**Addendum No. 1
to the
Supplemental Environmental Impact Report/
Environmental Impact Statement
Riverside-Corona Feeder Project
for the
Realignment of Reach G, Realignment of a Portion of Reach F, and the
Change in Equipment for the Sterling Pump Station**

Western Municipal Water District
14205 Meridian Parkway
Riverside, Ca 92518

Albert A. WEBB Associates
3788 McCray Street
Riverside, CA 92506

Figure 1 - Proposed Riverside-Corona Feeder Alignment with Previous Alignment/Location

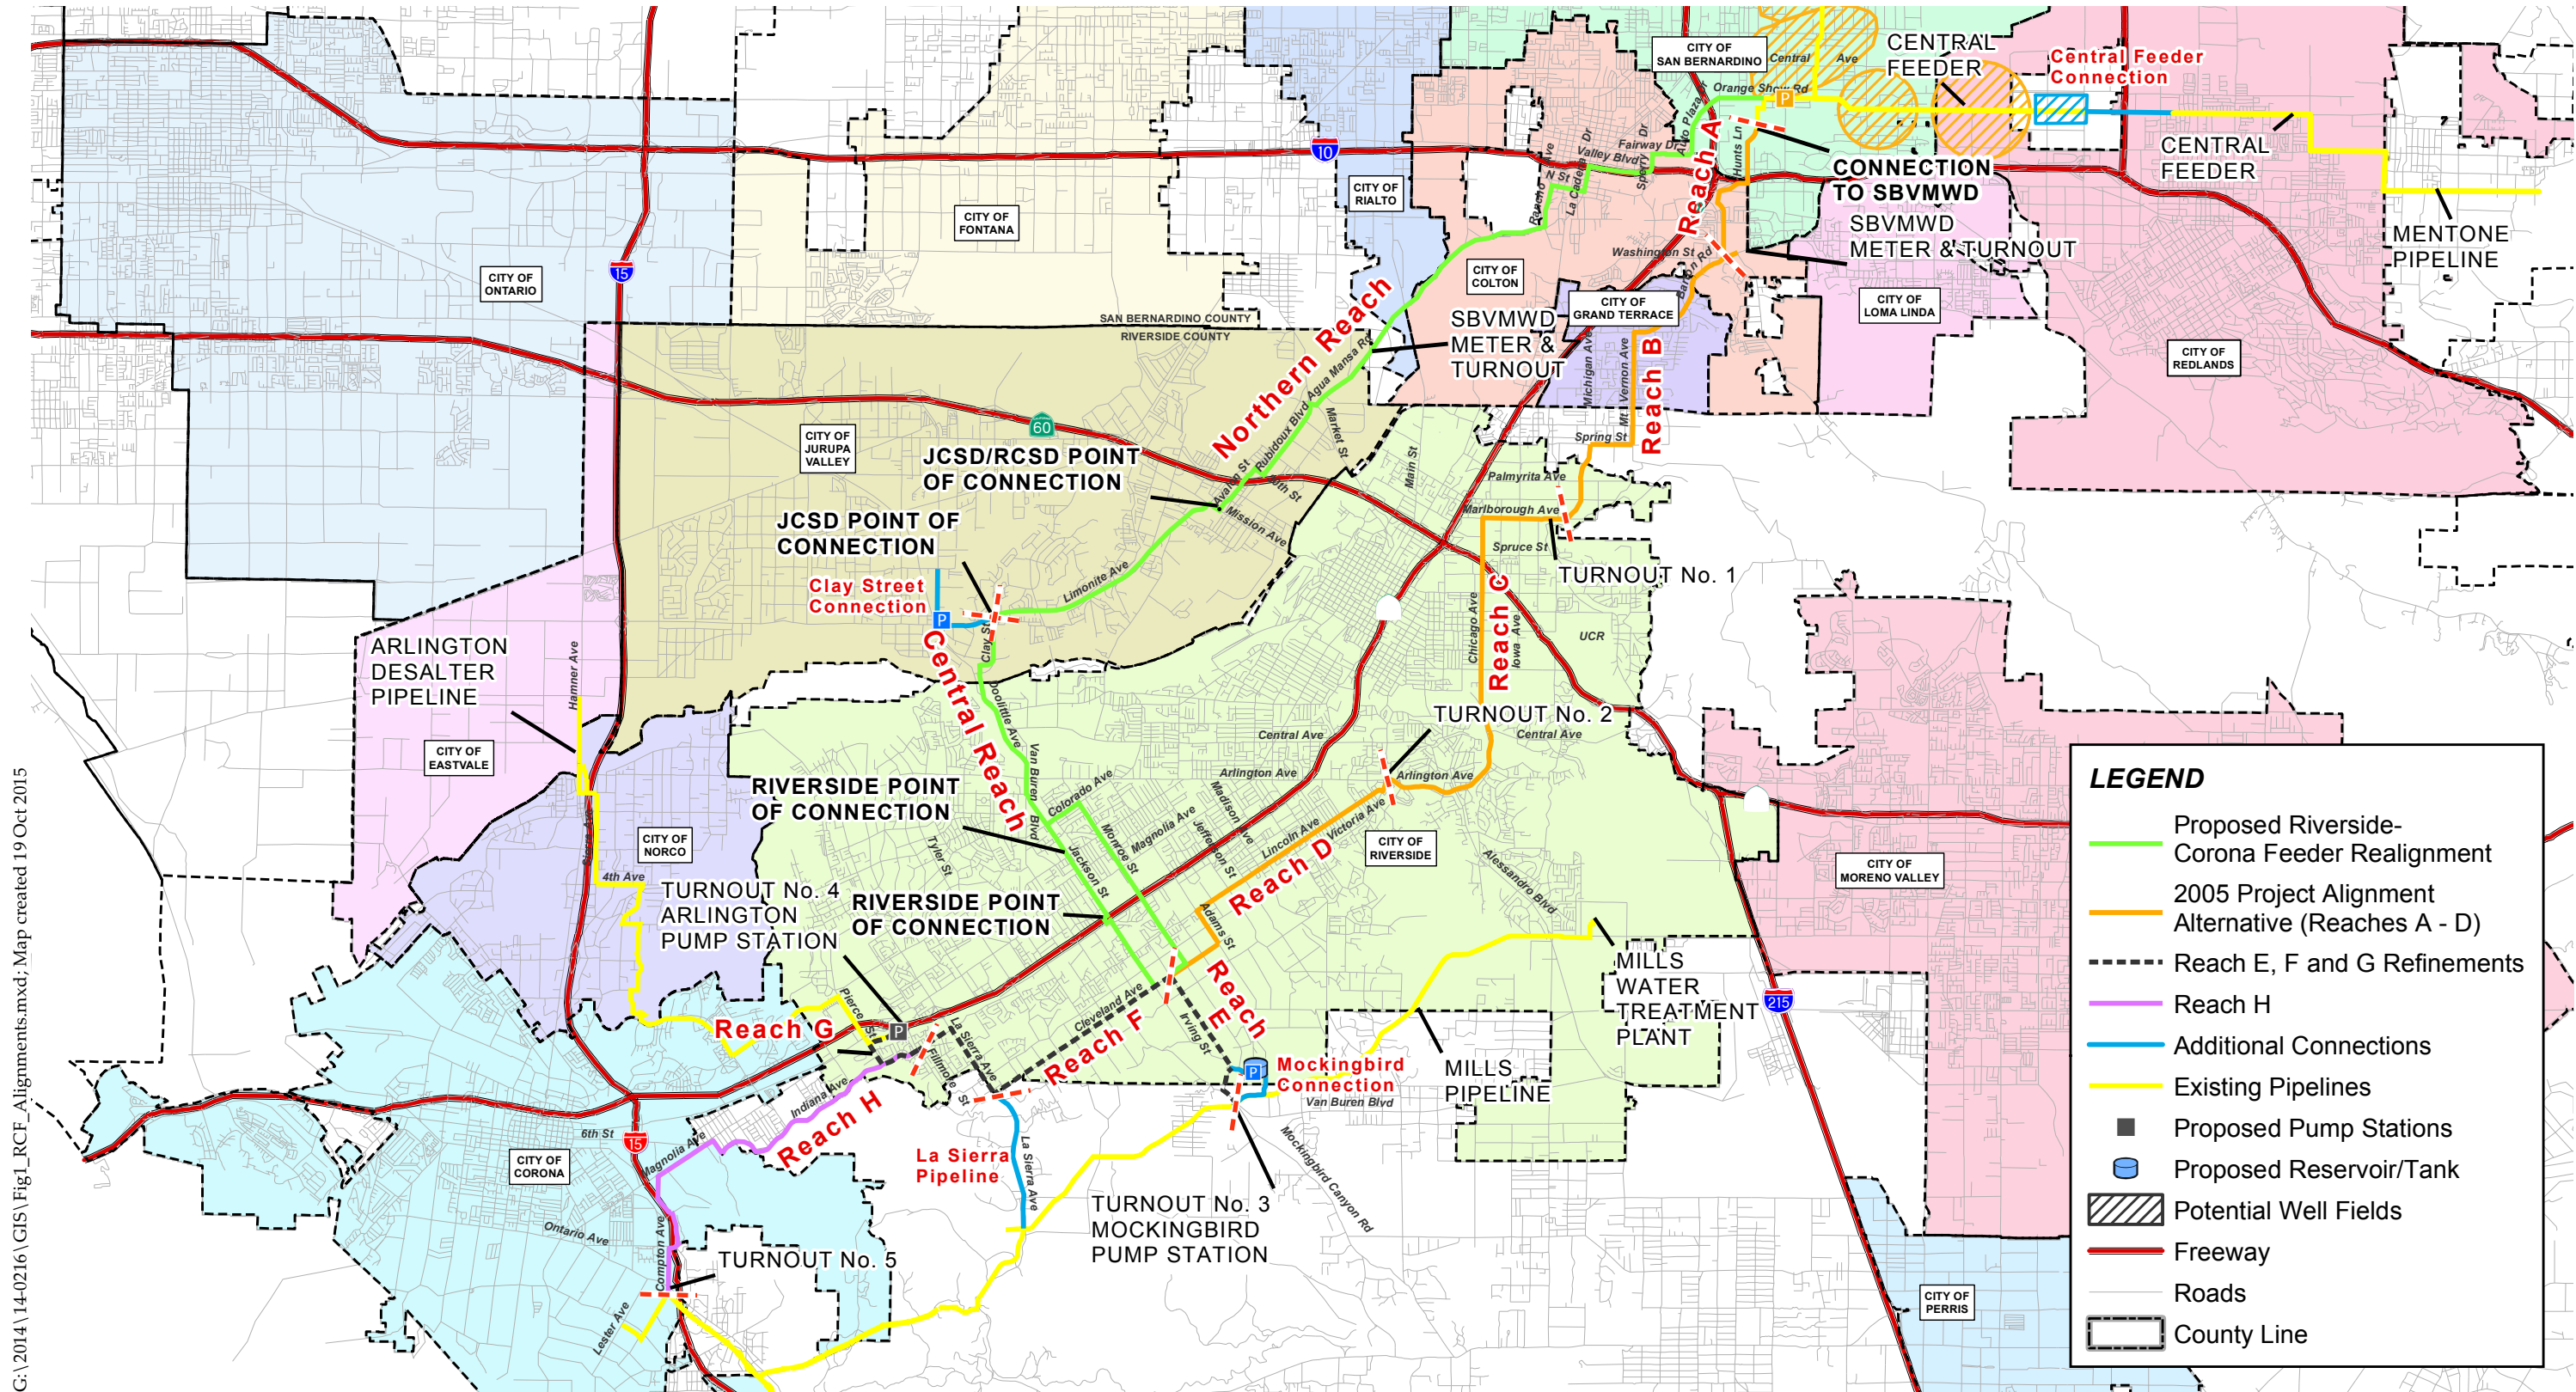
The 2005 PEIR evaluated Reaches A through H, with Reach A starting in San Bernardino and Reach H ending in Corona (**Figure 1**) and a pump station to be constructed near WMWD's Arlington Desalter. The majority of this alternative is located within the City of Riverside (Reaches B through H), with some sections traversing portions of the cities of Colton, Corona, and Grand Terrace, and the County of Riverside. Infrastructure proposed to be constructed in the 2005 PEIR includes: a 30-mile long feeder pipeline with one mainline meter and five metered turnouts, a 2,500 horsepower (hp) pump station designed to lift water from the City of Riverside's Waterman Pipeline into the 2005 Project Alignment which operates at an hydraulic gradient line (HGL) of 1250±, and up to twenty (20) 350 HP x 2,200 gallons per minute (GPM) new or existing groundwater production wells to be located within the San Bernardino Basin Area. (SEIR/EIS, p. 1.0-6)

Subsequent to certification of the 2005 PEIR, the alignment of Reaches F and G were refined slightly to provide connection to WMWD's Arlington Desalter Water Purification Facility. The Reaches F and G Refinement, the original alignment of Reach E, and construction and operation of the Sterling Pump Station were evaluated in the *Final Environmental Impact Report for the La Sierra Avenue Water Transmission Pipeline Project* (State Clearinghouse No. 200610115), which is referred to as the 2008 Refinement EIR³ in the SEIR/EIS. The 2008 Refinement EIR, which incorporated the 2005 PEIR by reference, was certified by WMWD on February 20, 2008. Although Reaches E, F, and G and the Sterling Pump Station were adequately evaluated in the 2008 Refinement EIR for CEQA purposes, these facilities are included as part of all alternatives evaluated in the SEIR/EIS for NEPA purposes.

Figure 2 - Pipe Alignment Segments

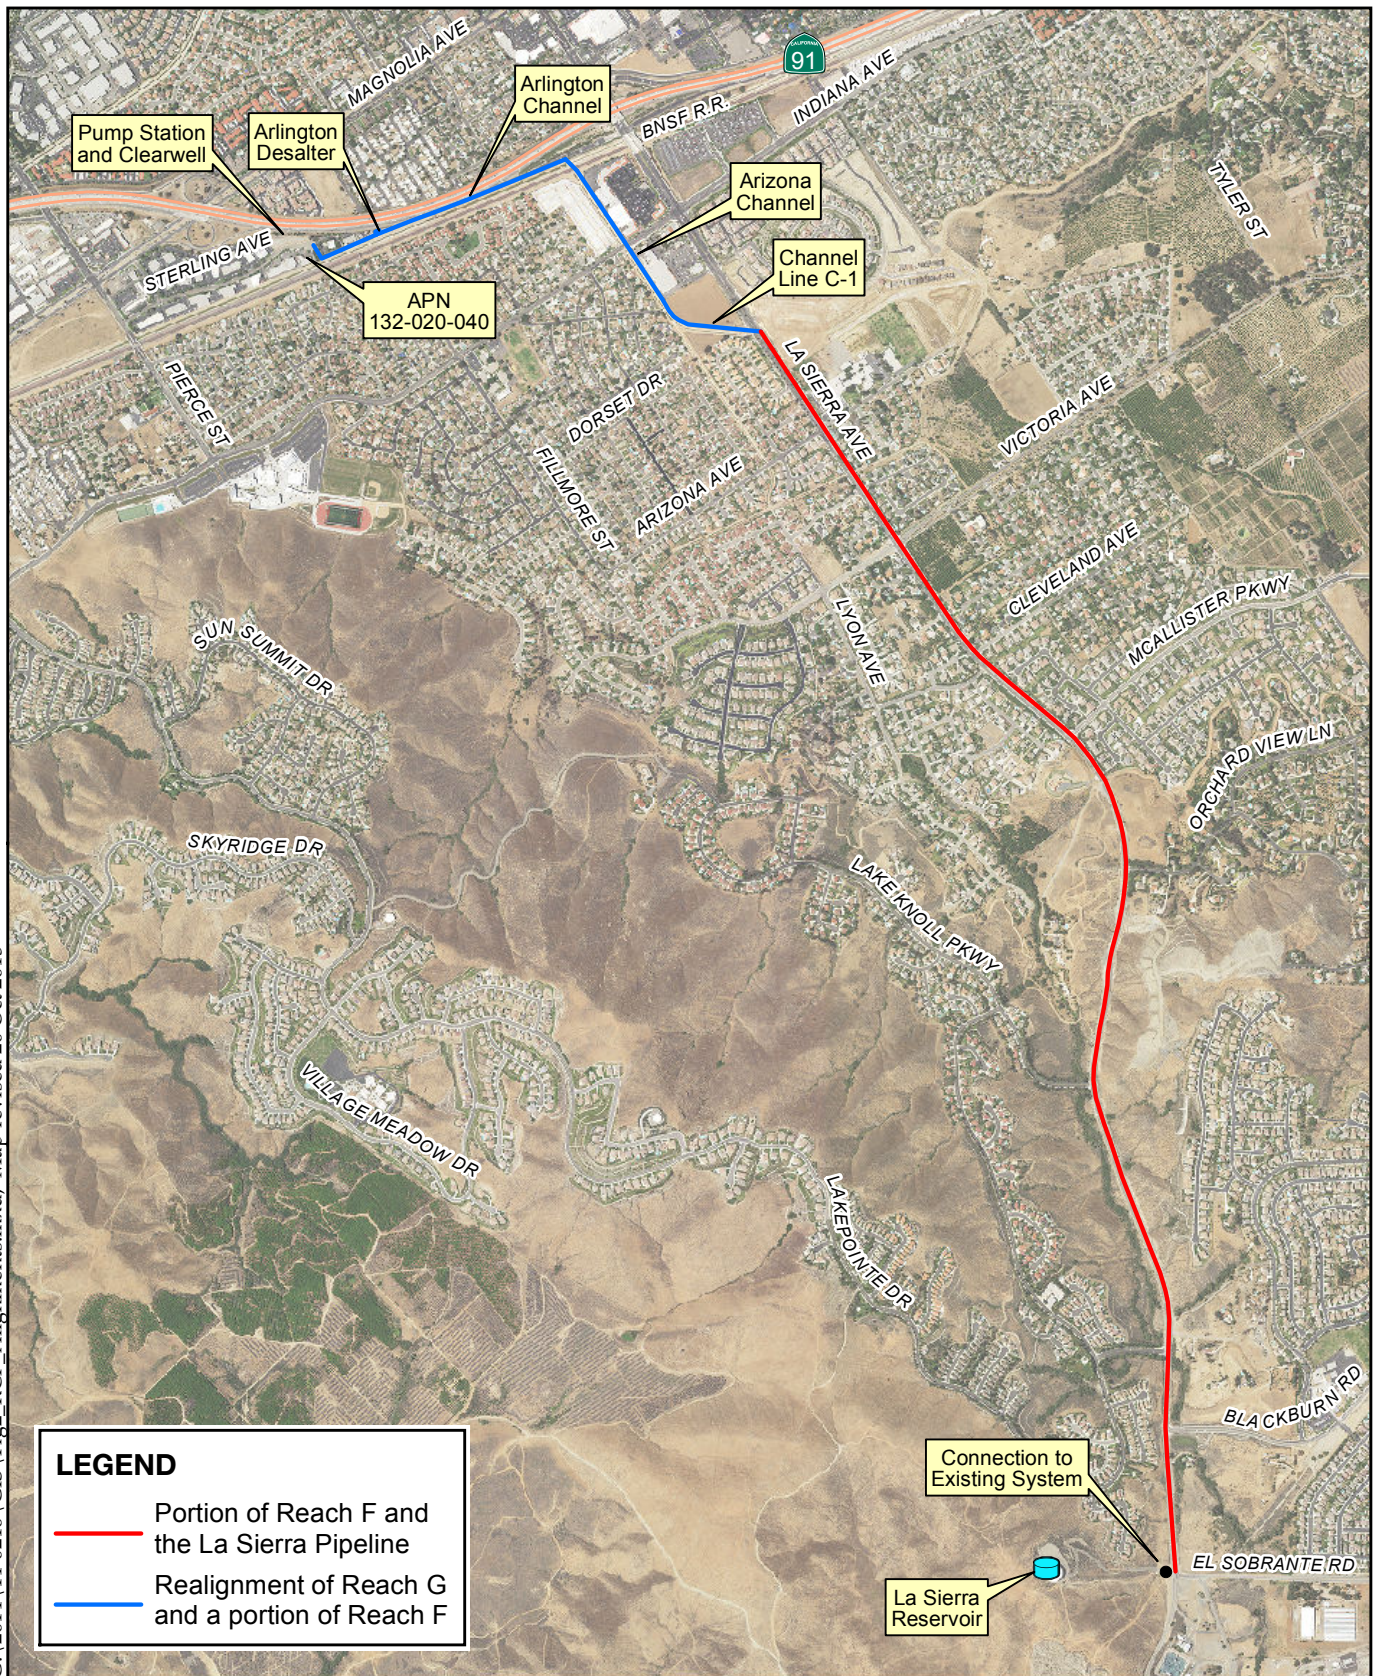
The facilities evaluated in Addendum No. 1 consist of realignment of Reach G, realignment of a portion of Reach F, and a change in the type and number of pumps to be installed in the Sterling Pump Station. No change to Reach E is proposed as part of the Modified Facilities.

The proposed realignment commences at the Arlington Desalter facility connecting through the site to the Sterling Pump Station for approximately 800 feet and then continues southwest across Sterling Avenue through a private parcel to the Riverside County Flood Control and Water Conservation District's (RCFCWCD's) Arlington Channel for approximately 275 feet, then northeast approximately 2,825 feet along the north side of the Burlington Northern and Santa Fe (BNSF) rail lines within the right-of-way (ROW) of RCFCWCD's Arizona Channel. At the Arizona Channel, jack and bore construction will be used to bore under the BNSF rail line and the channels. The pipeline will traverse approximately 1,900 feet southeast within the Arizona Channel ROW to RCFCWCD's Line C-1 ROW. The pipeline will continue in the Line C-1 ROW approximately 975 feet southeast to a point approximately 1,500 north of the intersection of La Sierra Avenue/Indiana Avenue. The pipeline will then continue in the original Reach F alignment to the intersection of La Sierra Avenue/Cleveland Avenue then continue south in La Sierra Avenue to El Sobrante Avenue following the La Sierra Pipeline alignment evaluated in the SEIR/EIS. The proposed realignment of Reach G and Reach F and the La Sierra Pipeline alignment are shown on **Figure 2 – Pipe Alignment Segments**.

The Modified Facilities proposes a change in the alignment of Reach G and a portion of Reach F and a change in the number and types of pumps at the Sterling Pump Station which are considered minor technical changes. As demonstrated in the following analysis, no new impacts or an increase in the severity of a previously identified significant impact will occur as a result of the Modified Facilities.
